SUNDRY NOTICES AND REPORTS ON WELLS

8. Well Name and No.
NDDUP UNIT 134

NDDUP Unit 134
30-015-28346
Yates Petroleum Corporation
May 12, 2014
Conditions of Approval

WELL NAME: NDDUP #134 **FIELD:** Dagger Draw

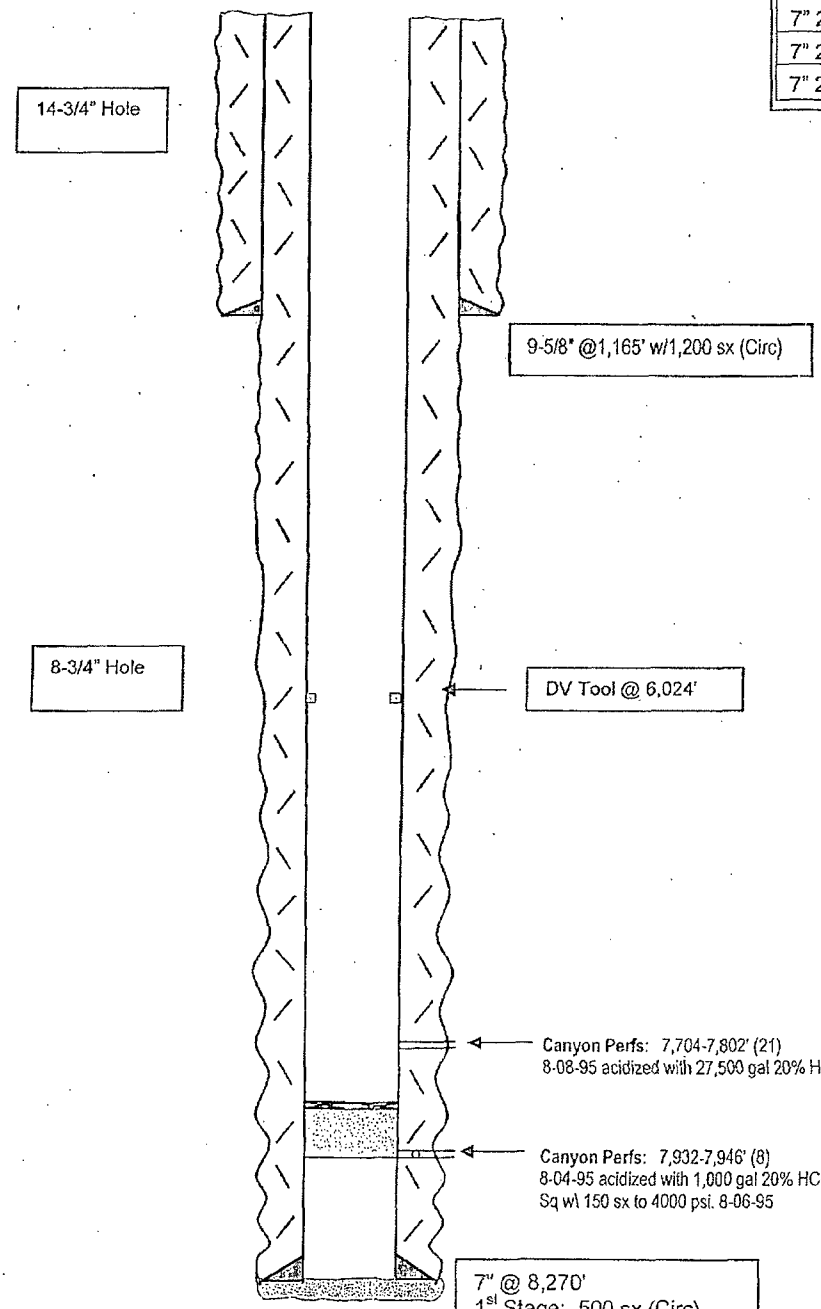
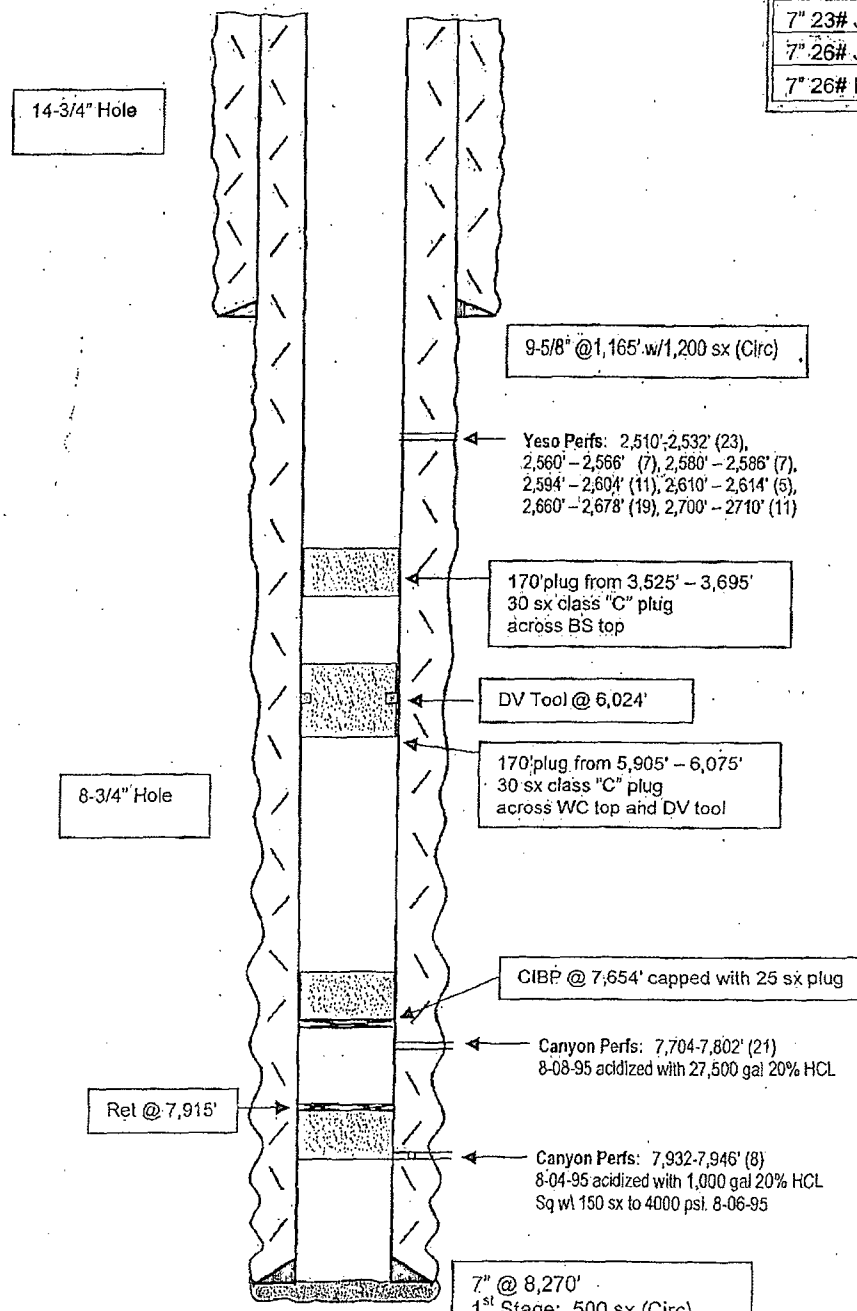
1. **Operator shall set CIBP at 7,654' and place 25 sx Class H Cement on top. WOC and tag at approximately 7,477'.**

2. **Operator shall place a balanced Class C Cement plug from 6,075'-5,905' as stated by operator. WOC and tag.**

3. **Operator shall place a balanced Class C Cement plug from 3,695'-3,525' as stated by operator.**

4. **Must conduct a casing integrity test before perforating and fracturing. Submit results to BLM. The CIT is to be performed on the production casing to max treating pressure. Notify BLM if test fails.**
